UNITED STATES PATENT AND TRADEMARK OFFICE

| APPLICATION NO. | FILING DATE | FIRST NAMED INVENTOR | ATTORNEY DOCKET NO. | CONFIRMATION NO. |
|-----------------|-------------|--------------------------|---------------------|------------------|
| 09/925,366 | 08/10/2001 | Thomas Gilbert Halvorsen | D-20814 | 4461 |

Office Action Summary

DETAILED ACTION

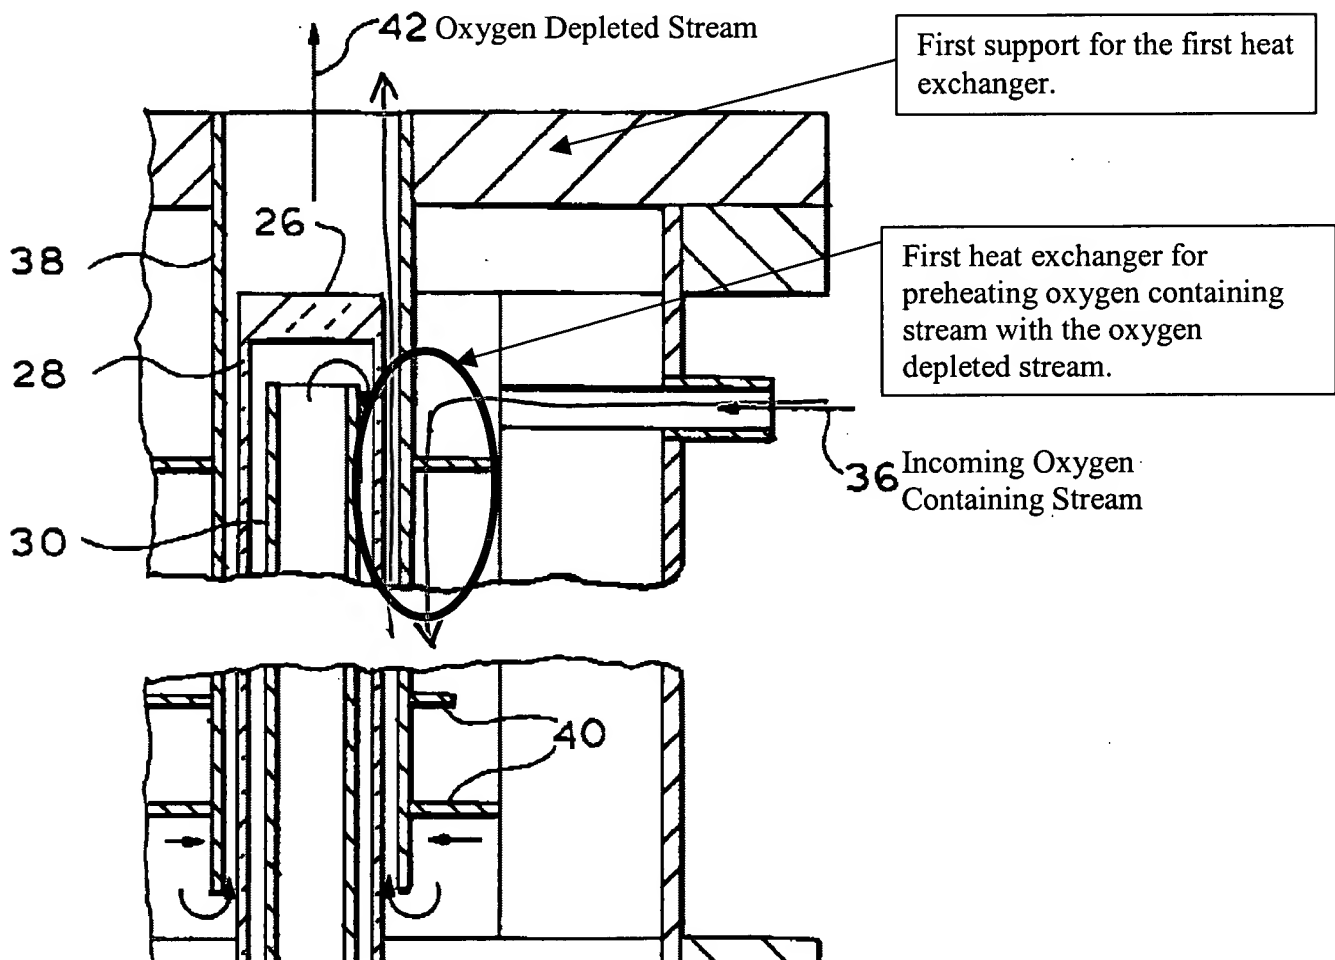
The next figure shows the second heat exchanger of Gottzmann et al.'655 for heating a reactant stream comprising at least one hydrocarbon and steam by indirect heat exchange with a synthesis gas product stream. stream. The flow of reactant stream is shown by blue line and the flow of product stream is shown by orange line.

Further, Gottzmann et al.'655 clearly discloses that there is very efficient heat transfer between gases in various annular passages (see column 8, line 66 to column 9, line 9). While that specific passage refers to Fig. 1, the same comments apply to Fig. 2 (see column 11, lines 7-9 which discloses that "Flow of oxygen-containing gas stream 36 in Fig. 2 is identical to that of Fig. 1 as are the reaction, heat transfer, and gas flow relationships.").

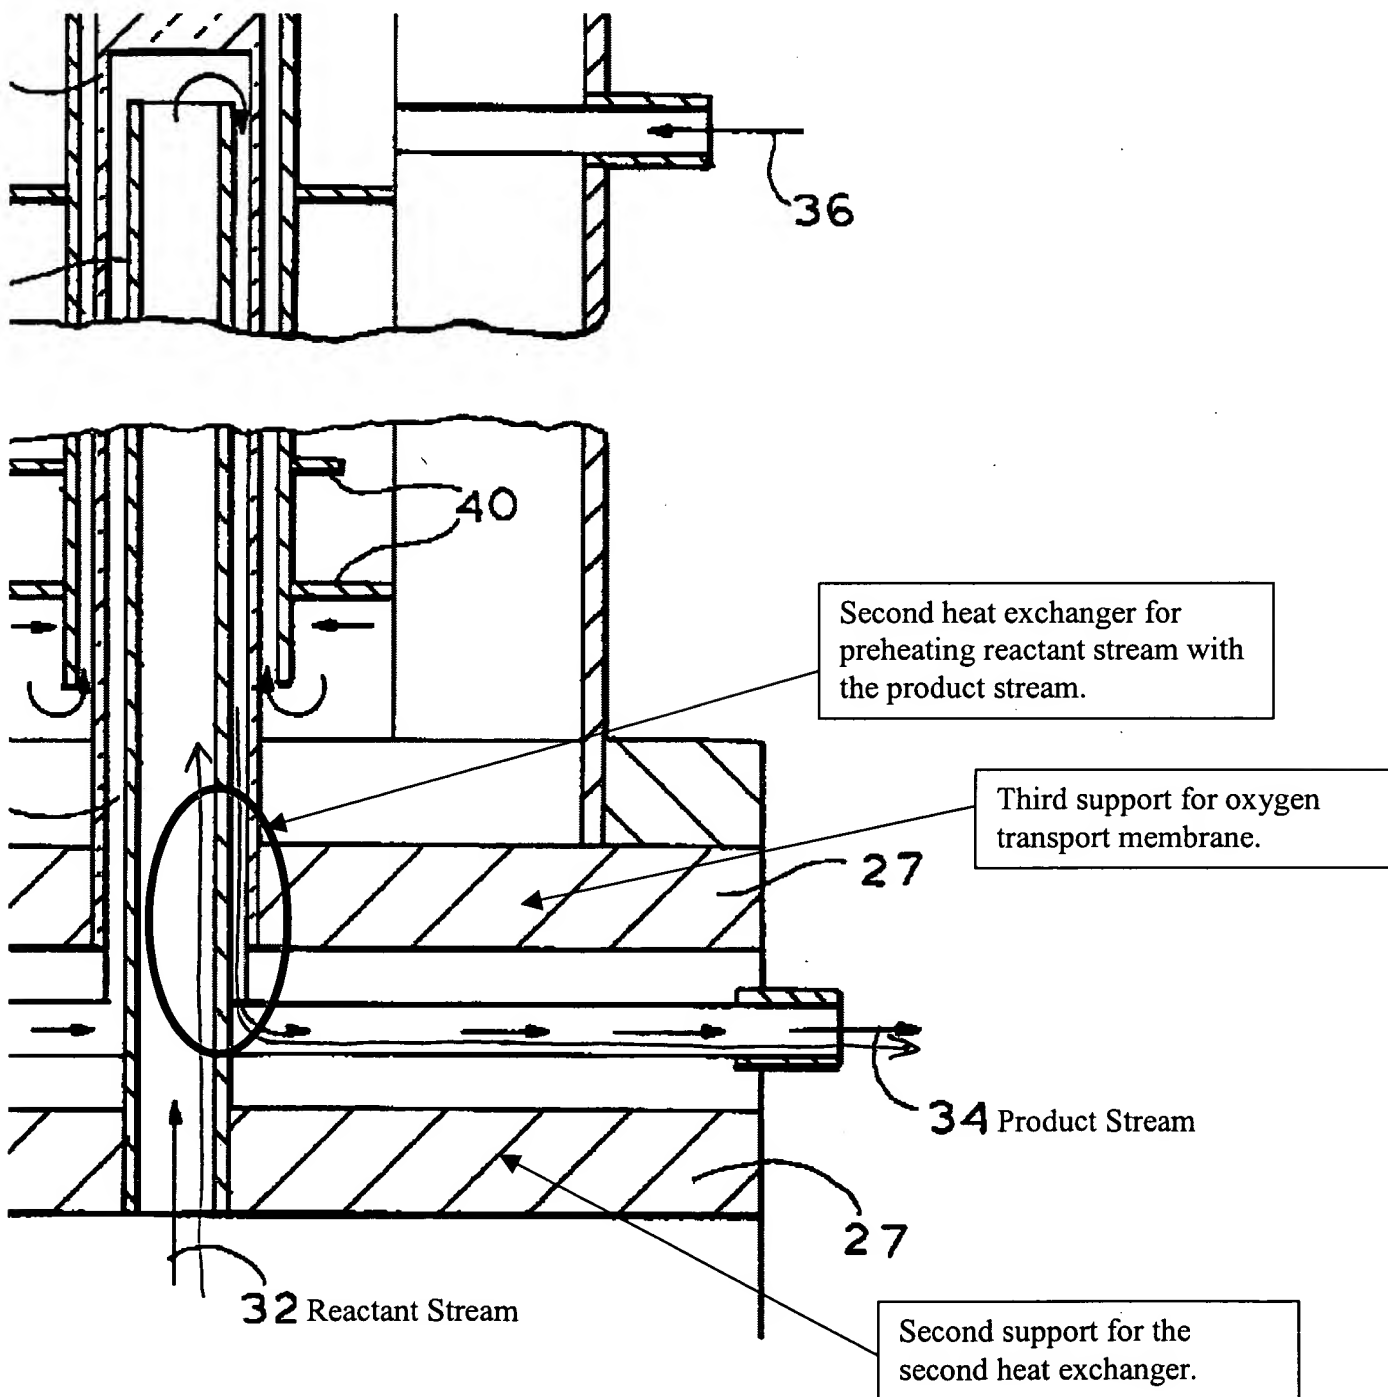
9. The applicant argues that Gottzmann et al.'655 does not have the heat exchangers of the present invention or their independent supports. This is not found persuasive. Gottzmann et al.'655

in Fig. 2 clearly shows two heat exchangers as recited in instant claims which are independently supported. To clarify examiner's position, the following are partial copies of Fig. 2 with additional annotations.

The following figure shows the first heat exchanger of Gottzmann et al.'655 for preheating oxygen containing stream by indirect heat exchange with the oxygen depleted stream. The flow of oxygen containing stream is shown by green line and the flow of oxygen depleted stream is shown by purple line.
